Inspection Photos

Operator: TEP ROCKY MOUNTAIN LLC #96850

Location ID: 323868

Juhan/14-26H, #323868 Annotation Report

5 - Observation

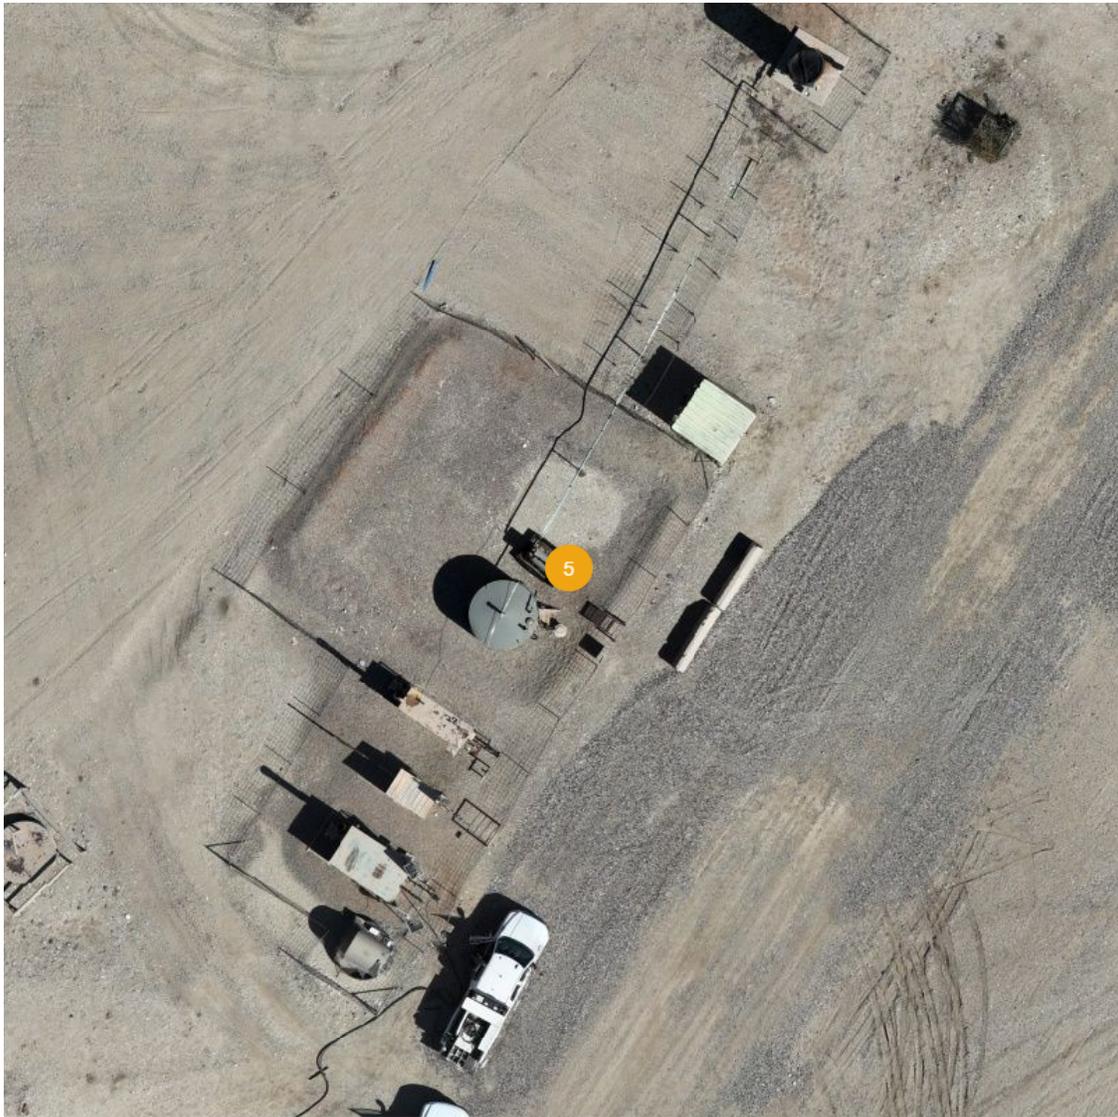
Wildlife protection BMPs missing or insufficient.

3 - Observation

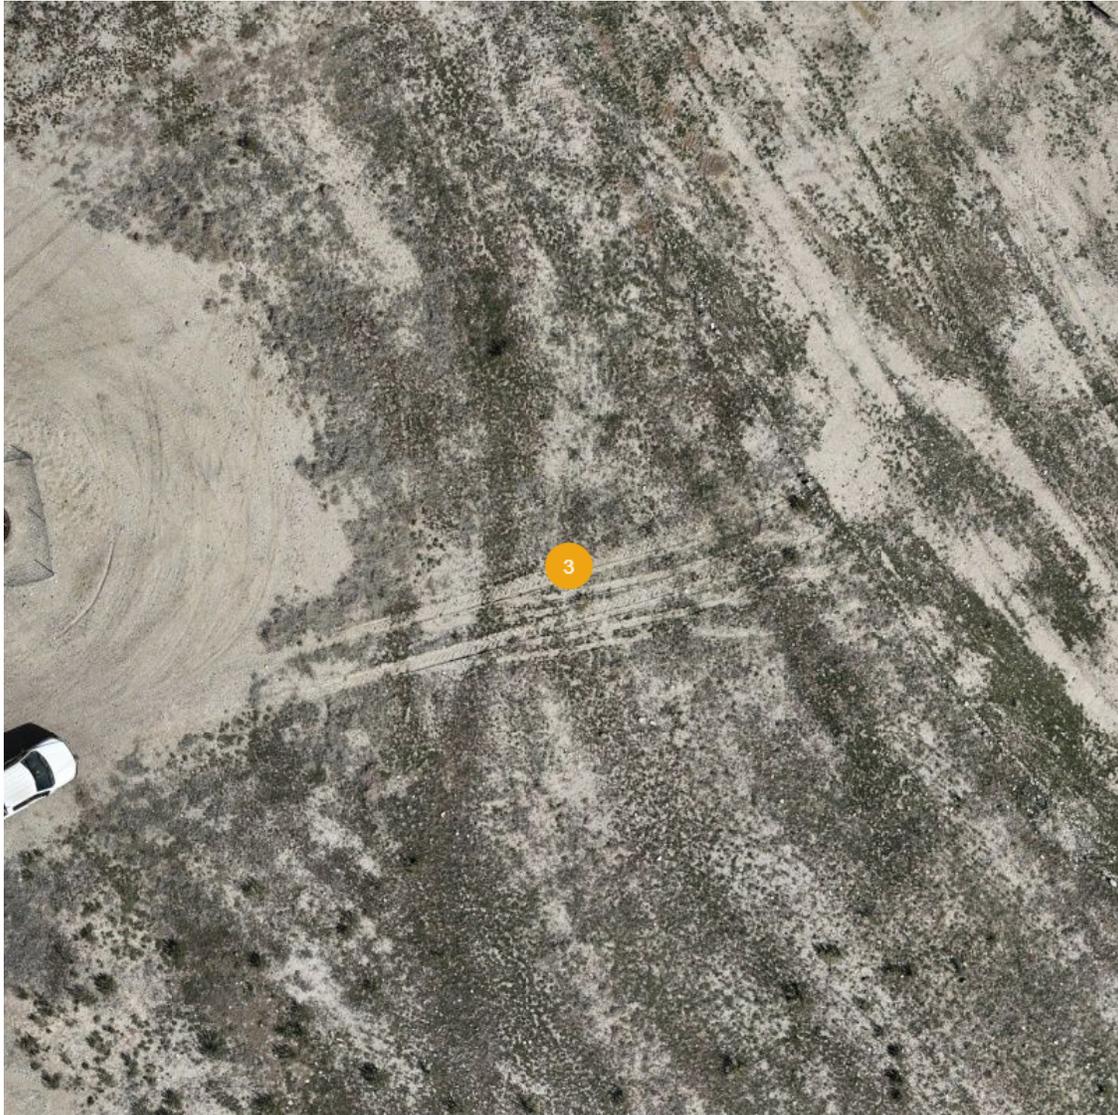
Summary:	Vehicle travel beyond the designated access road, and working pad surface.
Created:	Apr 8, 2025, 8:21am by Aaron Trujillo
Cost of Repair:	—
Lat/Long:	39.4920518, -107.8592894
Northing:	1612754.1 US ft
Easting:	2334244.9 US ft
Elevation:	-3.84 US ft
